MEMORANDUM

FOUNDATION INVESTIGATION REPORT
For
Eastbound Lane and Westbound Lane
Underpass Structures
At the Crossing of Eighth Line Road
And Proposed Hwy. #417
Twp. of Gloucester, Co. of Carleton
District No. 9 (Ottawa)
W.J. 67-F-114 -- W.P. 34-66-08

FOUNDATION INVESTIGATION REPORT
For
Eastbound Lane and Westbound Lane
Underpass Structures
At the Crossing of Eighth Line Road
And Proposed Hwy. #417
Twp. of Gloucester, Co. of Carleton
District No. 9 (Ottawa)
W.J. 67-F-114 -- W.P. 34-66-08

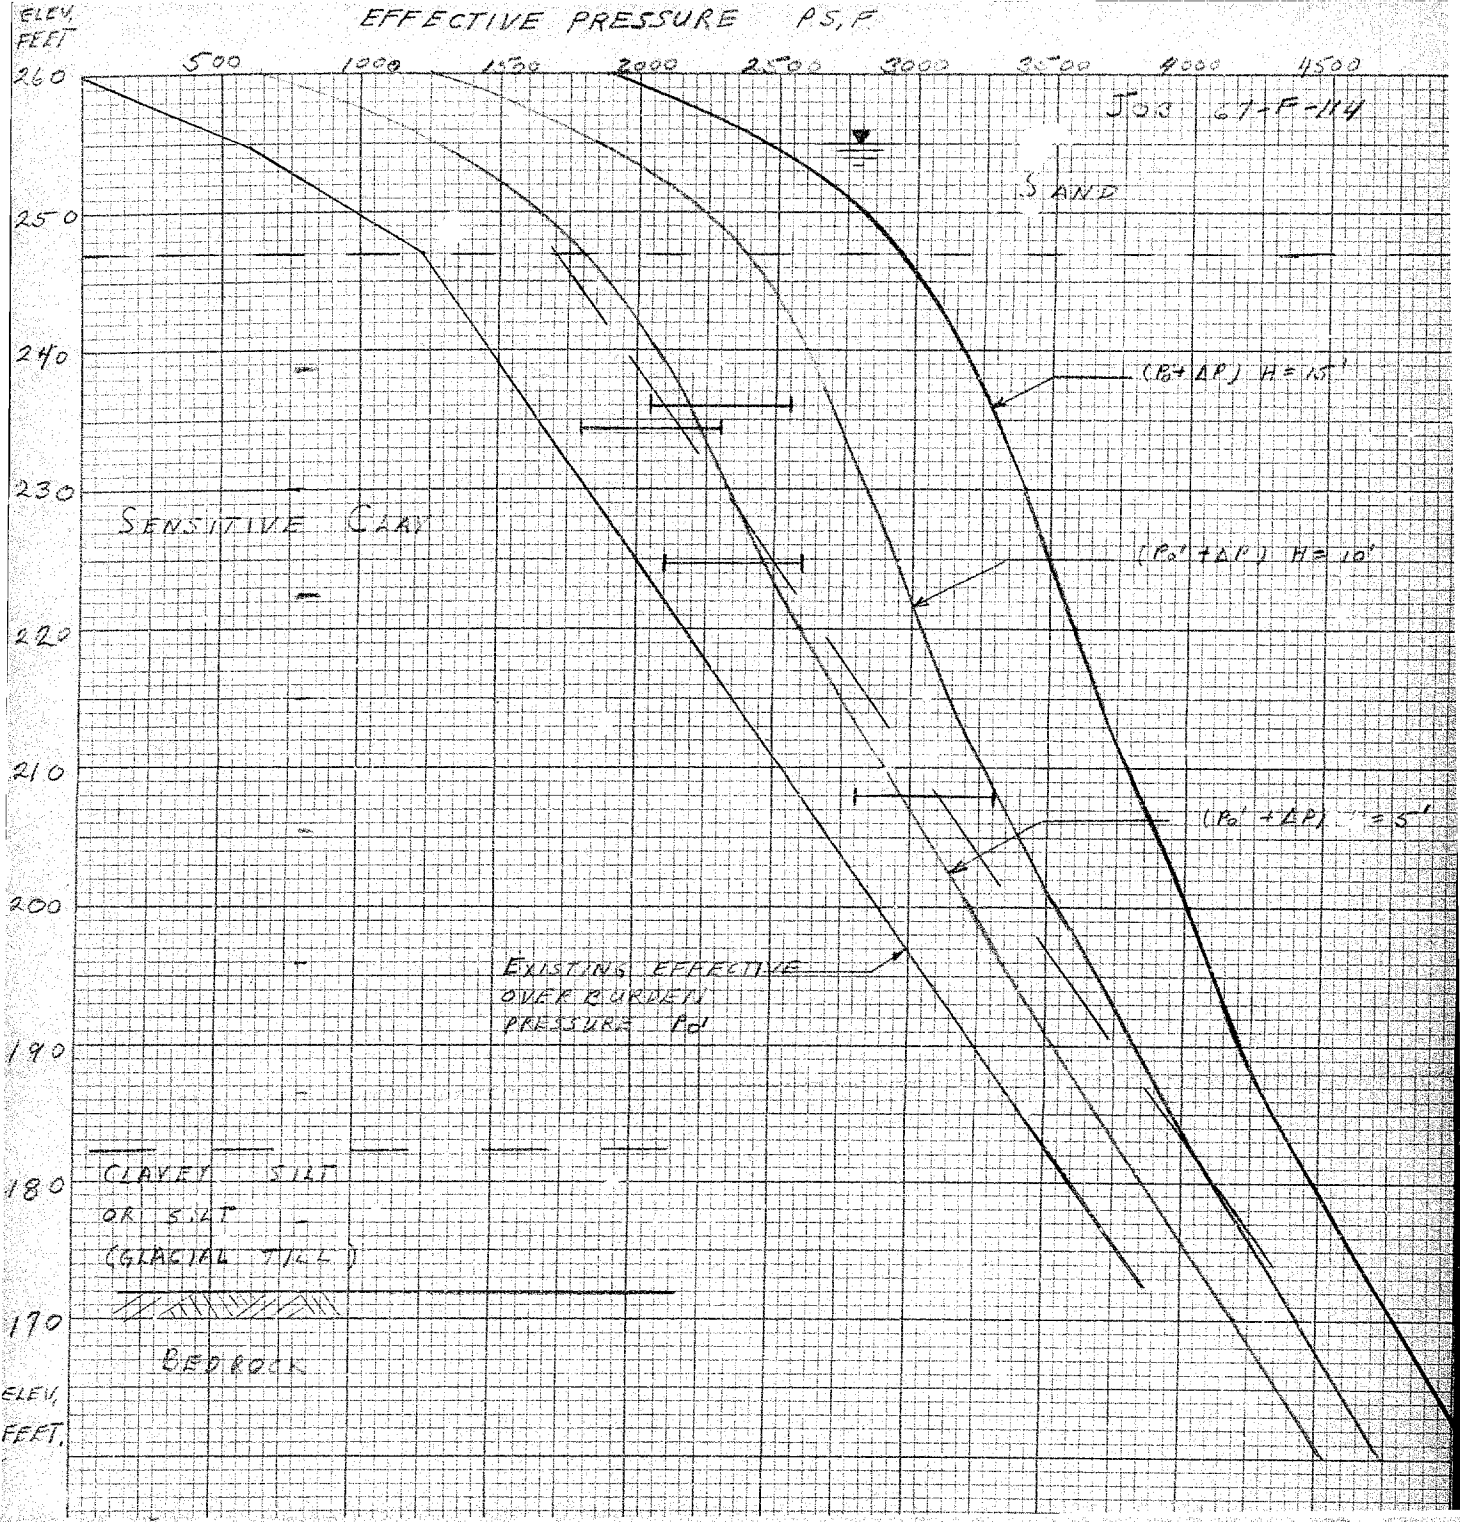
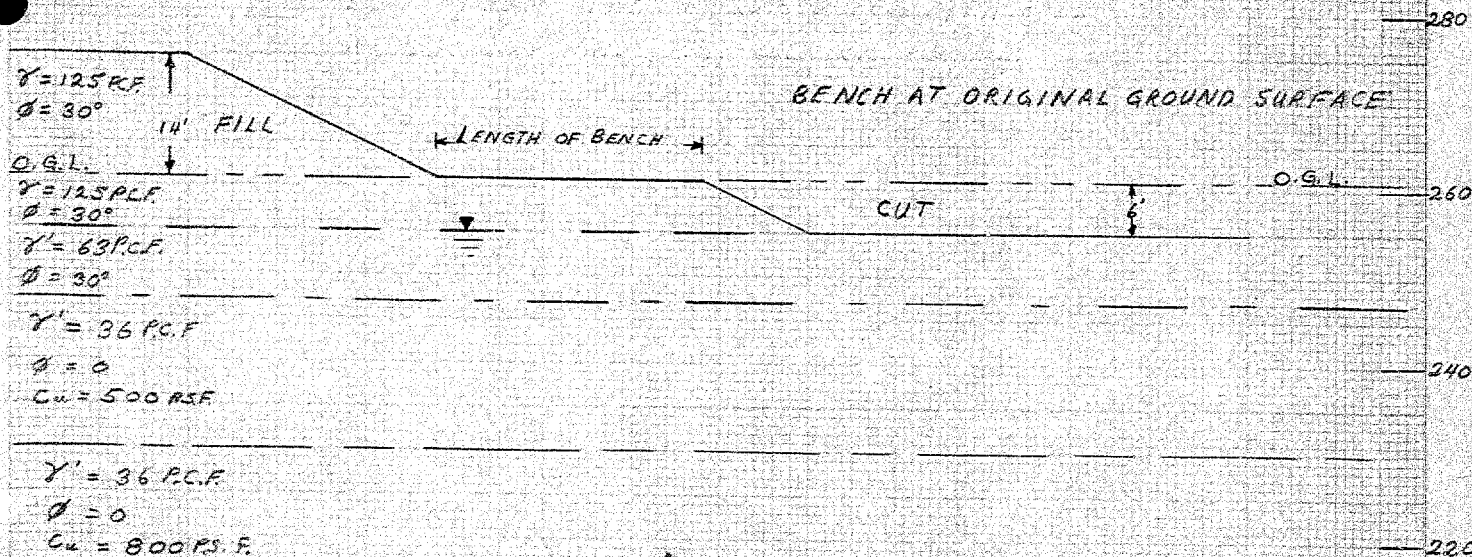
- a) Ht of Fill East Approach scales on Dwg to 14-15 ft. This ht. is 2-3' greater than recommended maximum of 12 ft.
- b). Surcharge of 4' should be applied only at crest and forward slope of fill. It is not necessary to provide the surcharge along the side slopes.
with surcharge of 4' $F=1.04$
therefore, very marginal.

- a) Use steel 'H' pile in preference to pipe pile if load is to be carried down to competent stratum. Reevaluate figure of 75 T/pile for $12\frac{3}{4}$ " ϕ pipe piles in view of -ve skin friction arising from consolidation settlement, if pipe piles used as friction piles.
- b) Surcharge only crest is forward slope of fill. F with surcharge = 1.03, marginal.

FACTOR OF SAFETY WITH 4'
SURCHARGE 1.041

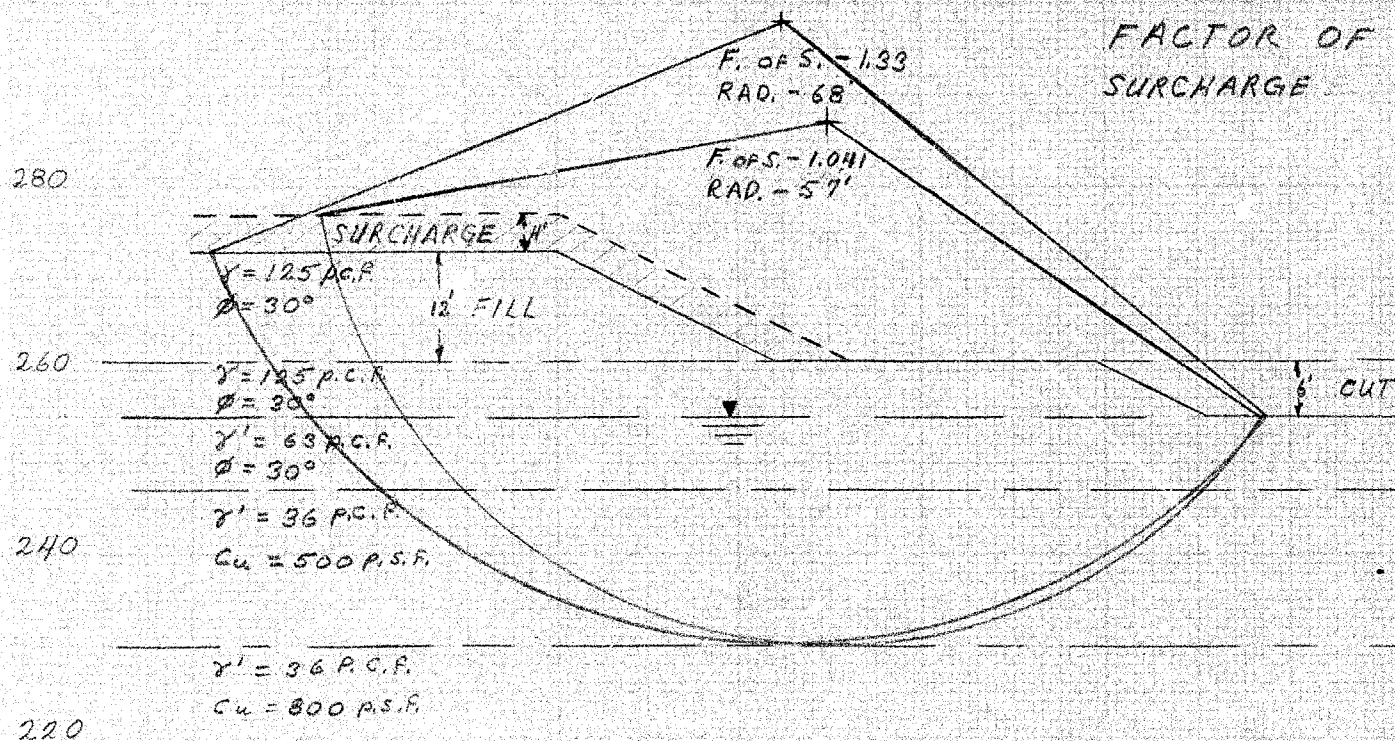
Also we note that the factor of safety with surcharge is in the area of 1.03 to 1.04 at the 7th and 8th lines and this does not seem to provide a sufficient margin of safety for construction purposes. Perhaps the District would comment on this aspect.
